**Comments of Pacific Gas and Electric Company**  
***Bidding Rules Enhancements Revised Straw Proposal 12/3/2015***

Submitted by	Company	Date Submitted
Maureen Quinlan 415-973-4958	Pacific Gas & Electric	December 17, 2015

Figure 5: Gas and Electric Day Timelines<sup>1</sup>

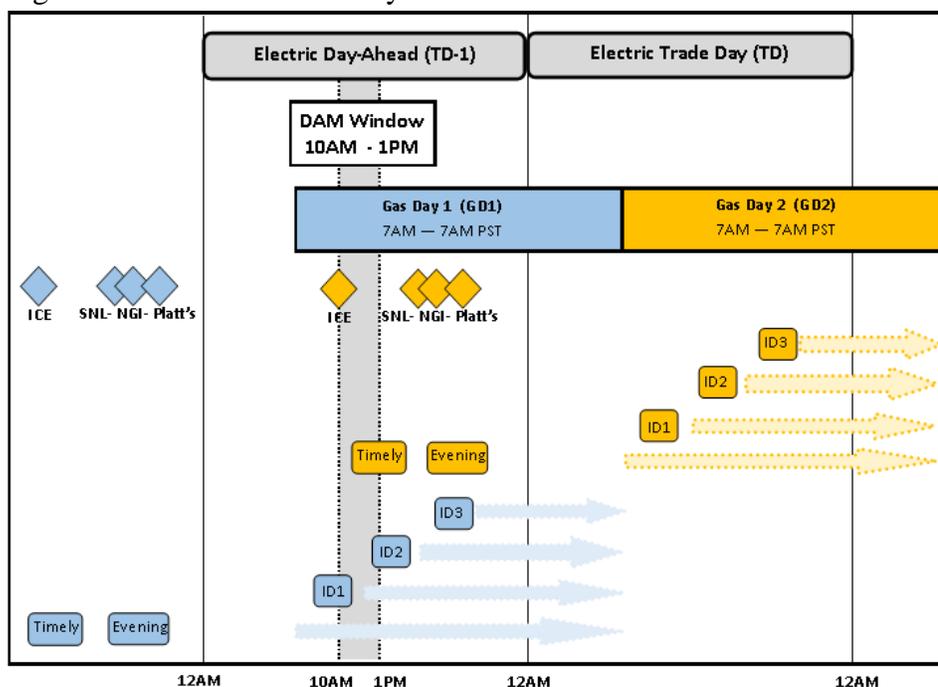
CAISO has proposed two potential changes to how it incorporates natural gas price information into proxy cost bid caps, both of which involve shifting the Day Ahead market close to 11:00 am in order to use the GD2 ICE index price (CAISO figure below). PG&E would support using a more timely gas price in the daily gas price index (GPI) if the incremental benefits outweighed the costs of doing so. PG&E believes that shifting the timing of the DA market process is a significant change for market participants, and should not be pursued without careful consideration of the cost and benefits to all market participants.

Market participants are currently able to manage day to day natural gas price variations using the 25% head room on the proxy-cost bid cap for commitment costs. As CAISO pointed out in the proposal, and DMM’s analysis shows, this 25% headroom is sufficient to manage gas price variation in the vast majority of circumstances. From 2005 to 2015, “only about 0.2 percent of trades at the PG&E Citygate and 0.5 percent of trades at the SoCal Citygate and Border in the ICE natural gas day-ahead market for GD2 were at prices that exceeded the ICE day-ahead index for GD1 by more than 25 percent<sup>2</sup>.” For significant gas price changes, CAISO also has a manual gas price spike procedure to update its gas price inputs in the DA market. Given that the current CAISO rules and procedures can accommodate more than 99% of gas purchases made by market participants, CAISO should carefully consider whether further refinements are truly needed, and if so scale the solution appropriately for the potential incremental benefits.

PG&E encourages CAISO to further support its position that “the benefits from improving the GPI cost input likely outweigh the drawbacks of moving the day-ahead market back an hour.” At a minimum, CAISO and stakeholders should have a robust discussion about the impacts of the later market close and later market results publication. In an earlier phase of this initiative, CAISO and stakeholders considered options for shifting the DA market timeline to comply with FERC Order 809 and new gas transmission scheduling deadlines. One of the FERC 809 compliance options was to
